Subject OWMP Public Hearing

**Draft Oak Woodland Management Plan Comments**  
**Attn: Monique Wilber**  
**2850 Fairlane Court**  
**Placerville, CA 95667**

**Subject: Comments on the Draft Oak Woodland Management Plan**

Figure 1.

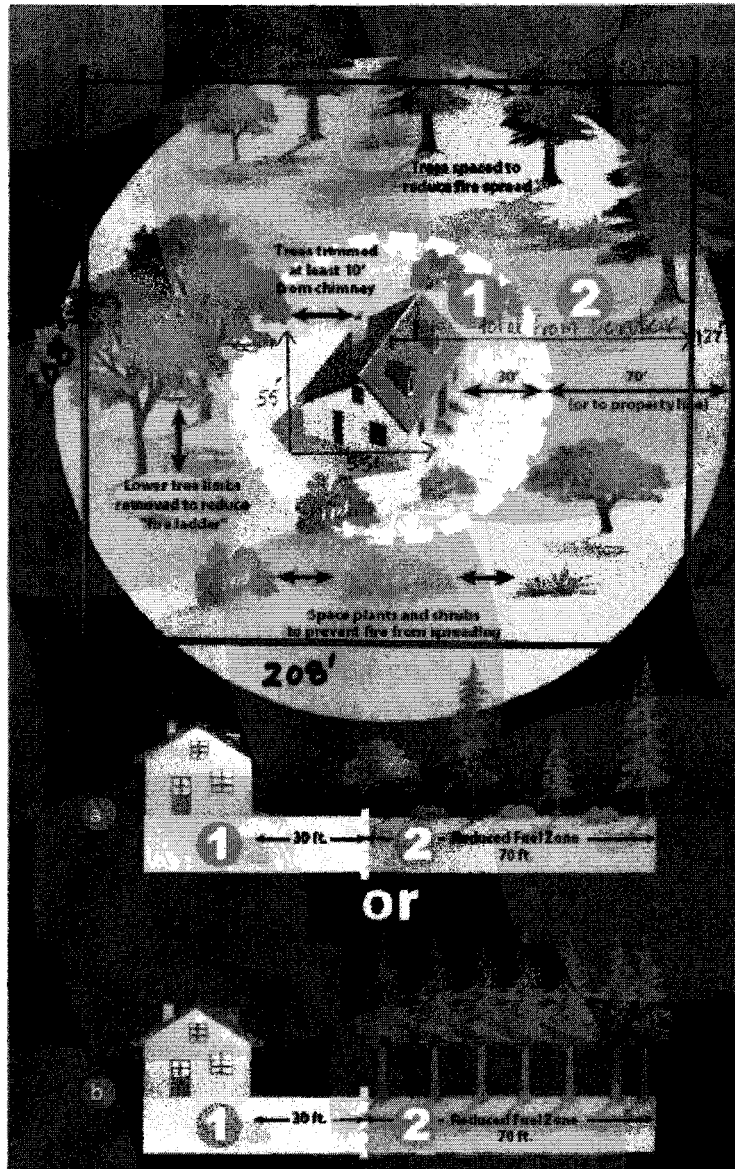
If you put a 3000 sq.ft. house (dimensions 55ft. X 55ft.) on a one acre lot (208 ft. X 280ft) there would be no room for oak replacement and the landowner would be forced to pay the fee for the canopy cover removed which would be more than half of the lot just to meet the minimum PRC 4291 specifications.

50 ft. X 50ft.  
corner remaining to  
plant within.
